Consideration of Comments

Project Name: 2016-04 Modifications to PRC-025-1 | PRC-025-2
Comment Period Start Date: 10/30/2017
Comment Period End Date: 12/14/2017

PRC-025 modifications drawing.docx

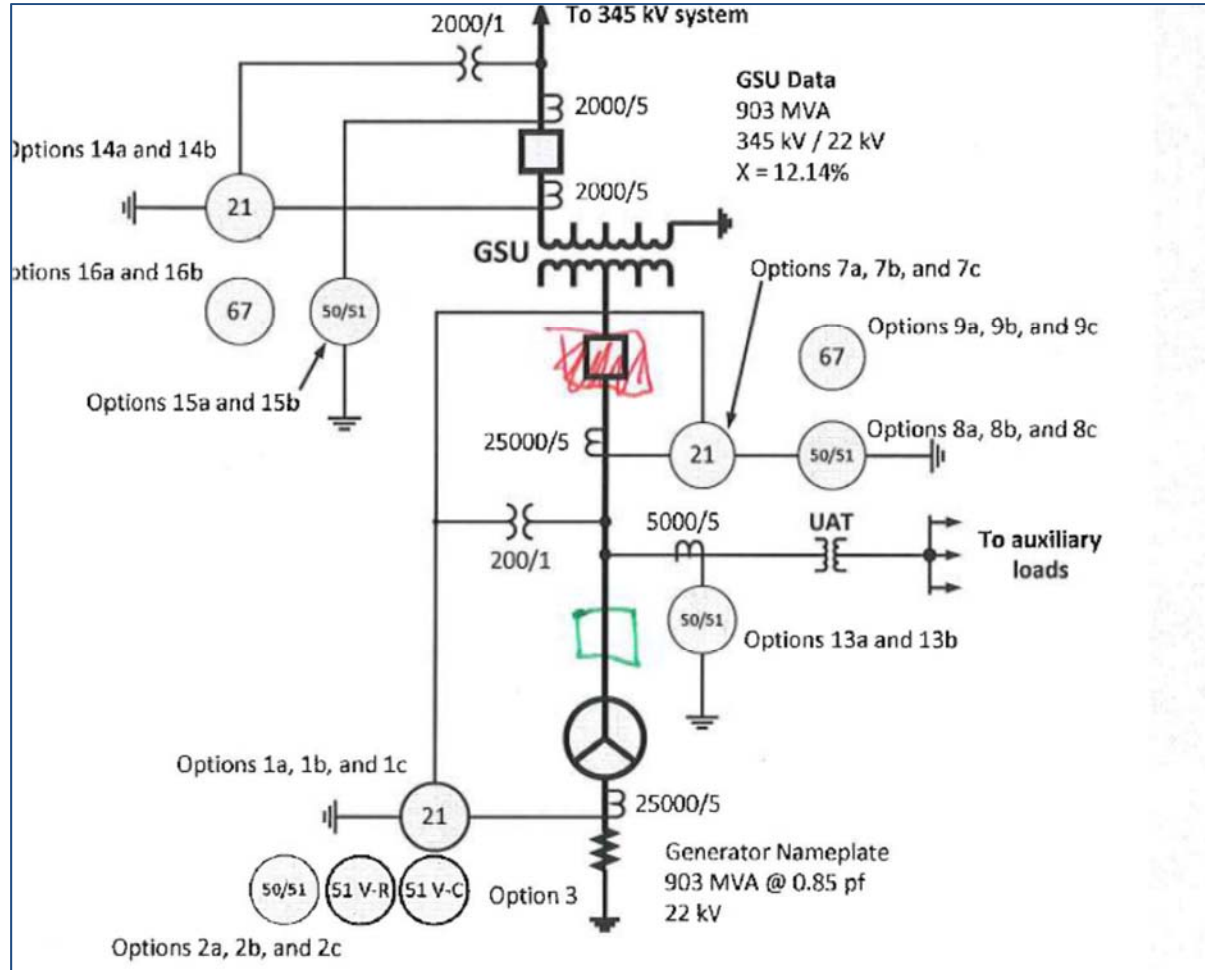
Xcel Energy has concerns that the changes to the "Application" column for Options 7a-7c, 8a-8c, and 9a-9c are somewhat misleading and the description is inconsistent with Figure 5. We do acknowledge that this is partially a carryover issue from PRC-025-1.

The "Application" column for options 7, 8 & 9 describe "Relays installed on the generator side of the Generator step-up transformer..." Figure 5 shows that the current transformers for the load dependent relays to which options 7-9 are applicable are actually applied on the generator or the generator breaker and not specifically on the low side of the GSU. Note that many microprocessor based generator protection relays allow you to select the signal source for the current input to the 21 function such that either neutral or line side current transformers may be used for the current signal input to the 21 device associated with the generator. In other words, not all generator load dependent relays are fed neutral side current transformers. From this perspective, it would be unclear whether the entity should be using option 1a-1c or option 7a-7c for evaluating the loadability of the 21 function or options 2a-2c or option 8z-8c for the 50/51 functions.

Note that on Figure 5, the location of the generator breaker relative to the generator bus tap to the UAT is incorrect for most typical applications. In most applications when a generator breaker is provided, it will be on the generator bus between the generator and the bus tap to the UAT so that the UAT remains in service from the GSU when the generator breaker is open and the generator is offline. There would be operational value in a generator breaker between the UAT tap and GSU LV winding as shown in Figure 5. By moving the location of the generator breaker to the correct location between the generator and UAT bus tap on Figure 5, all inconsistency would be eliminated and would greatly improve the clarity of the differences between options 1 vs. 7 and 2 vs. 8. See attached file for markup of Figure 5.

Based on the criteria included in the "settings criteria" column for options 1, 2, 7 & 8, the key difference to use when determining which option to use is dependent on if the current transformer feeding the load dependent relay includes measurement of current flowing to the UAT in addition to that flowing to the LV winding of the GSU from the generator.

Thank you for your comment. Options 1a-1c and 7a-7c are differentiated by where the current transformer (CT) is located and not the breaker location. Options 2a-2c and 8a-8c are also differentiated by where the current transformer (CT) is located and not the breaker location. Options 7a-7c and 8a-8c are generally transmission related to address varying entity configurations. For example, where a Transmission Owner owns the generator step-up (GSU) transformer. Option 1a-1c and 2a-2c are directed to Generator Owner protection relaying.

The representation of the breaker in Figure 5 is for illustration and may not be representative of all configurations.
